TECHNICAL INFORMATION

- Subject** ▶ Modification of Handle Cover
- For Models** ▶ 5026D, 5036D, 5046D, 5621D, 5621RD
- Country** ▶ All countries
- Description** ▶ As illustrated below, one of the holes for tapping screw has been modified for smoother elevation of Motor Housing for depth adjustment.

Magnified view of the modified hole
(view from the battery side)

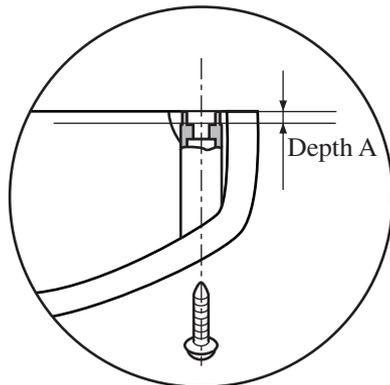
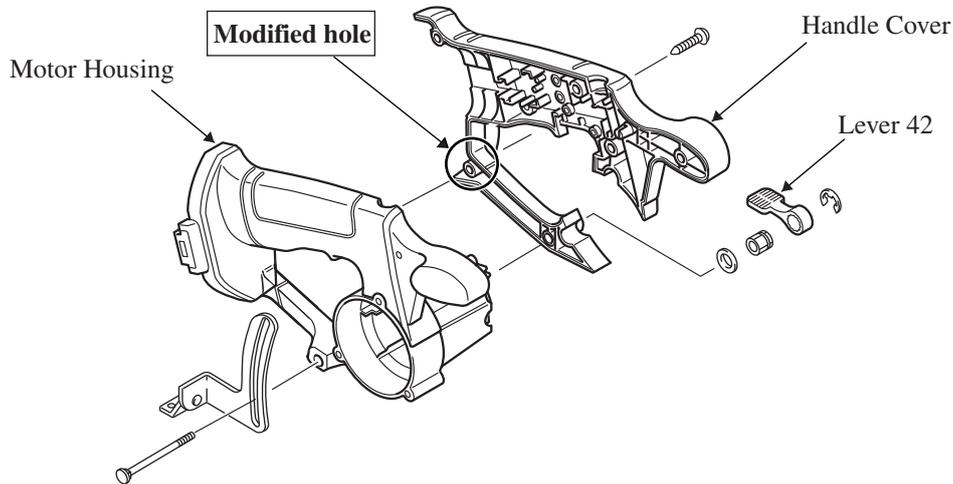
▶ Current	▶ New
Part No.	416691-1	417170-2
Depth A	4.0mm	3.6mm

Depth A has been reduced by 0.4mm. (See the figure on left.)
Due to this modification, Handle Cover and Motor Housing can be joined more firmly for smoother action of Lever 42.

Item No.	Current part	Q'ty	I/C	New part	Q'ty	Note
5026DW: 005	Handle Cover 416691-1	1	←	Handle Cover 417170-2	1	The current part can be used for the repair of 5621D / 5621RD. But Always use the new part for 5026D / 5036D / 5046D.
5036DW: 005						
5046DW: 005						
5621DW: 004						
5621RDW: 017
